Research Reactor Center
 University of Missouri-Columbia

Reference: Docket 50-186
 University of Missouri – Columbia Research Reactor
 Amended Facility License R-103

SUBJECT: Written communication as specified by 10 CFR 50.4(b)(1) requesting U.S. Nuclear Regulatory Commission approval to amend the Technical Specifications appended to Facility License R-103 pursuant to 10 CFR 50.59(c) and 10 CFR 50.90

Attachment: Revised Technical Specification 3.3, Pages 3 of 5 and 5 of 5

Theory of Operation

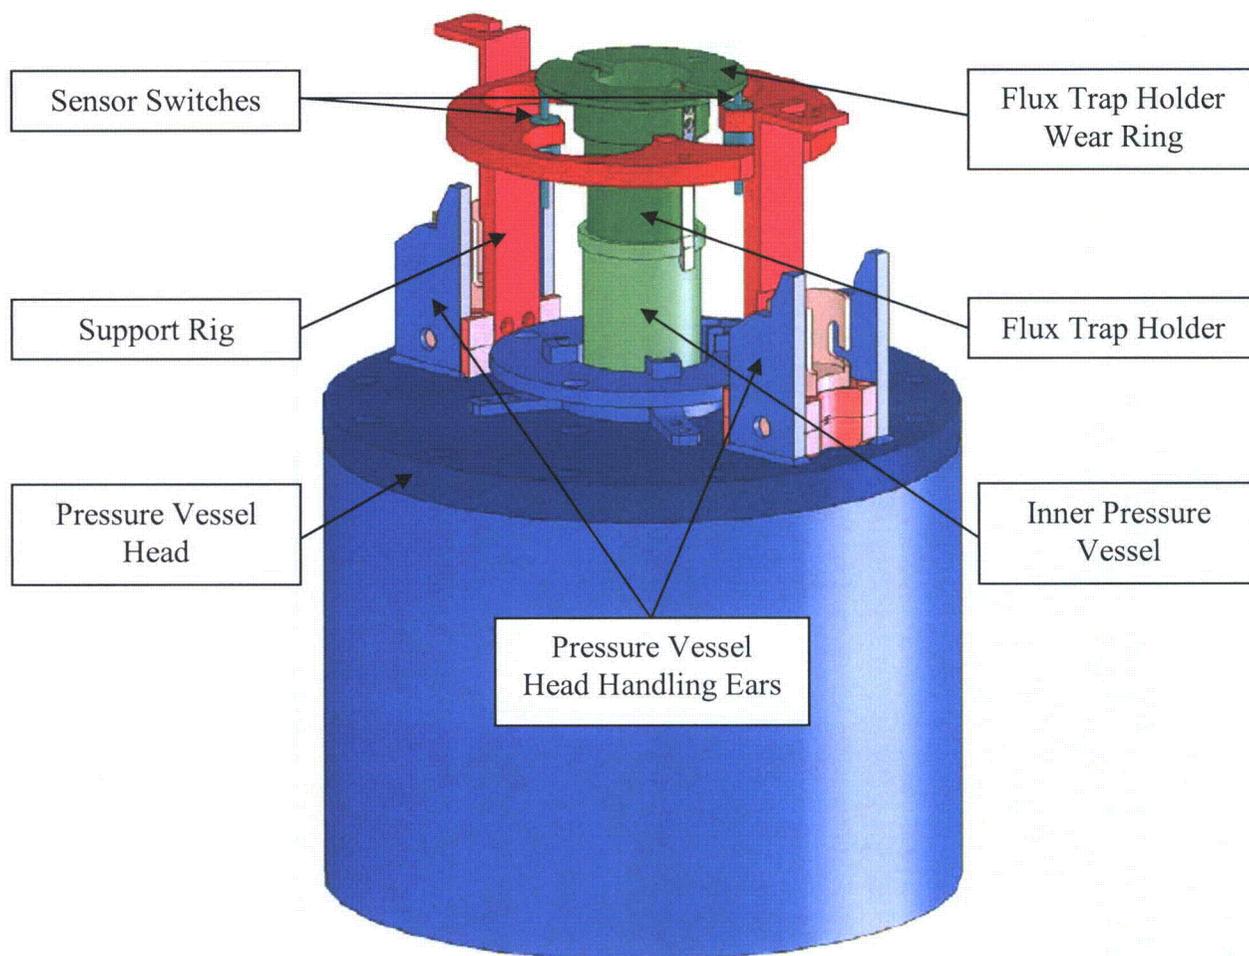
Modification Record 08-5, “Install Temporary Prototype of the Flux-trap Irradiations Reactivity Safety Trip (FIRST) Device,” documented the installation of a testing prototype that was not connected to the reactor safety system. The prototype was installed in December 2008, and tested almost continuously since that time (see “Test” Section).

The FIRST instrument channels will use two independent sensors to detect the position of the Center Test Hole Canister. When a sensor is ‘made-up,’ a relay coil is energized, maintaining a normally open contact in the closed position. This contact is one of several in a series that make up one leg of the 24 VDC input to the reactor safety system. This configuration is duplicated for the other sensor. When a sensor is no longer ‘made-up,’ the relay coil de-energizes, opening a contact, thus interrupting the 24 VDC input signal to the safety system. The resulting trip of the Non-Coincidence Logic Unit (NCLU) will de-energize the Trip Actuator Amplifiers (TAAs) and scram the reactor. This action ensures that if the position of the Center Test Hole Canister or Strainer changes from its secured and latched position, reactor operation will cease. Conversely,

if the sensors are not 'made-up,' the TAAs cannot be reset. This ensures that the Center Test Hole Canister must be installed in order to start up and operate the reactor.

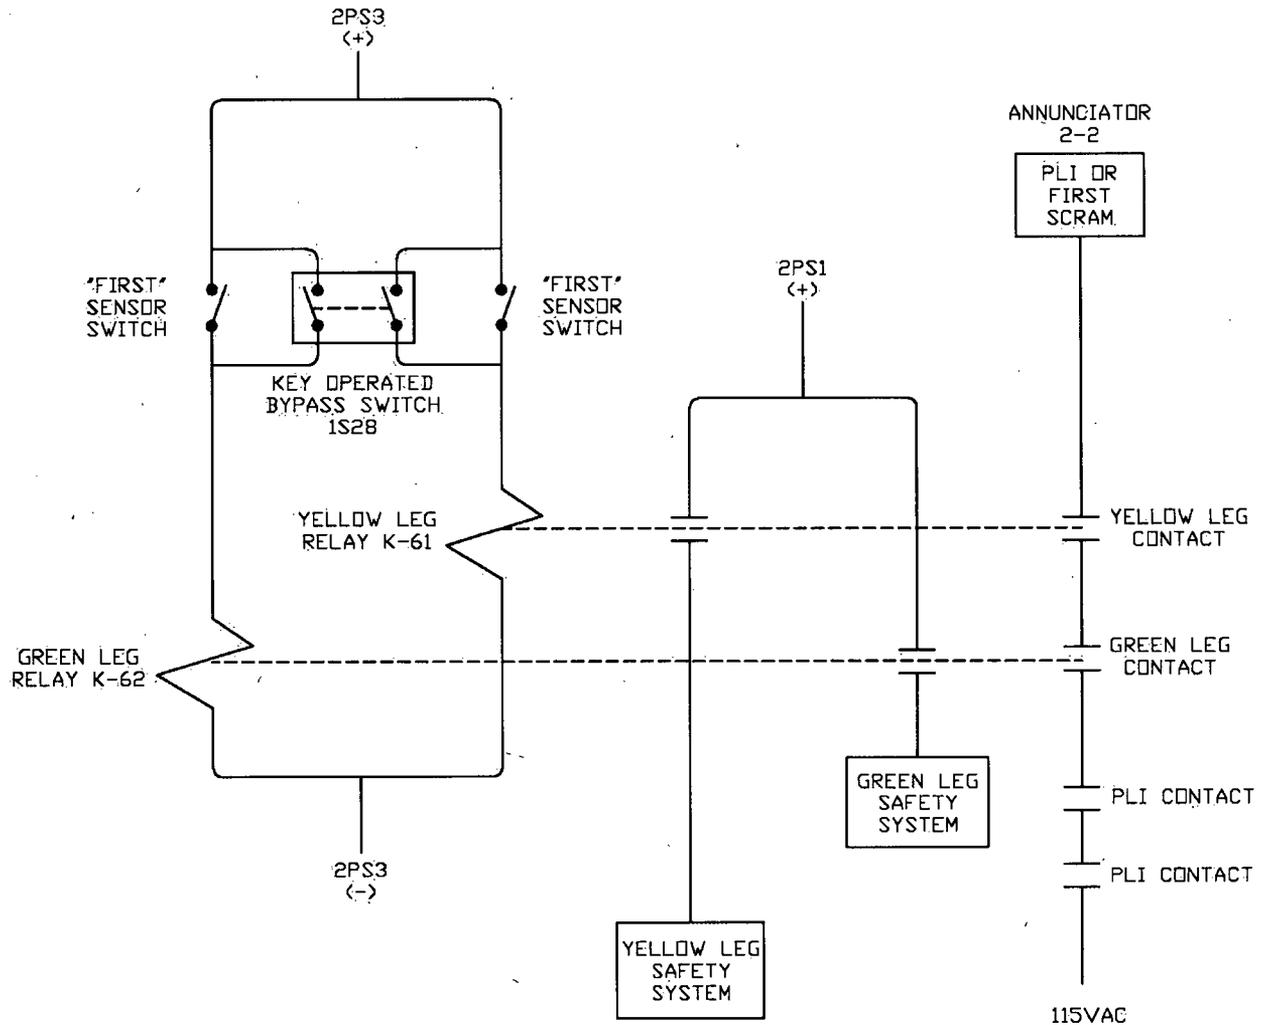
The support rig will attach to the reactor pressure vessel head via the existing vessel head handling ears, and will support and vertically align the two independent switches that close when the Center Test Hole Canister is in its secured and latched position. The support rig will be fabricated from 6061-T6 Aluminum and 304 Stainless Steel and designed using rack and pinion engagement pins to engage the existing handling ears of the pressure vessel head, provide a means to be installed, removed and stored, and allow physical access to all bolts of the pressure vessel head should the device prove unable to be disengaged and removed underwater. The rack and pinion engagement pins will be operated using a 2-inch rotating rod (a common handling tool in the pool), and will have opposed direction of rotation to counter any induced moment.

The switches will be adjustable in height, held in place using jam nuts, and be provided protective collars to prevent over travel of the switches. This condition would only occur in the event of improper handling or improper installation of the support rig.
